PCI-SIG ENGINEERING CHANGE NOTICE

TITLE:	OCuLink Memory Map Change
DATE:	Decmeber 9, 2016
AFFECTED DOCUMENT:	OCuLink Specification version 1.0
SPONSOR:	Bob Pebly (Intel), Jay Neer, Melwyn Kallickal (Molex), Alex Haser (Molex)

Figure A-1. Cable Management Interface Memory Map

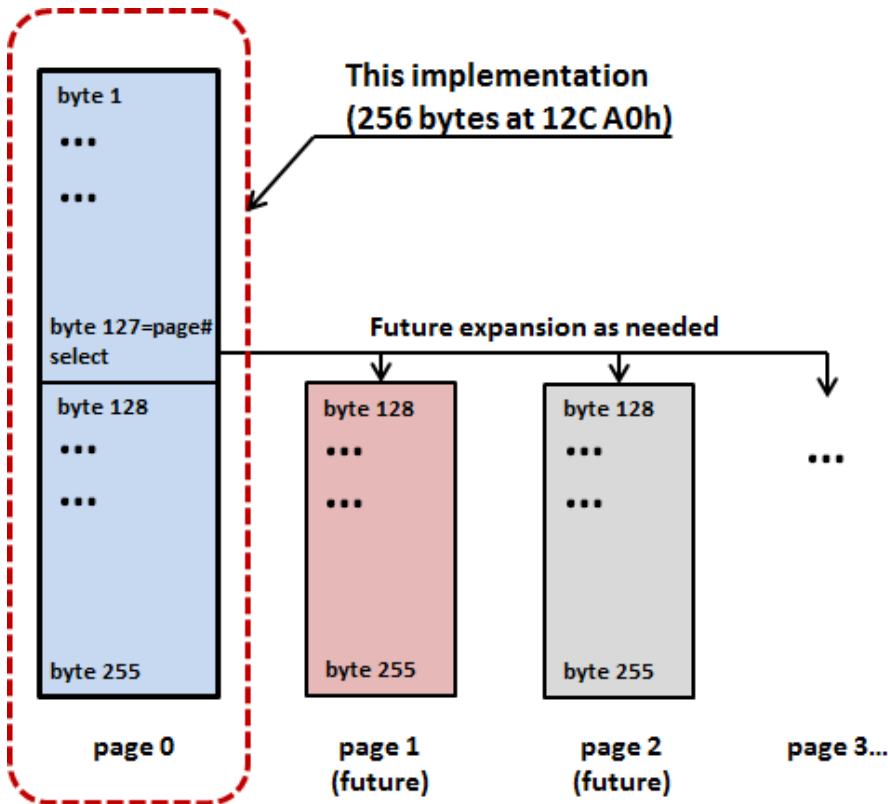
Change Sections A, A.1 and A.2 as follows:

This appendix defines the memory map for the cable management interface. The structure of the map is shown in [Figure A-1](#).

The map is arranged into a single lower page address space of 128 bytes and one mandatory upper address page. Additional upper address pages are not defined in this Specification, but may be used in future expansions.
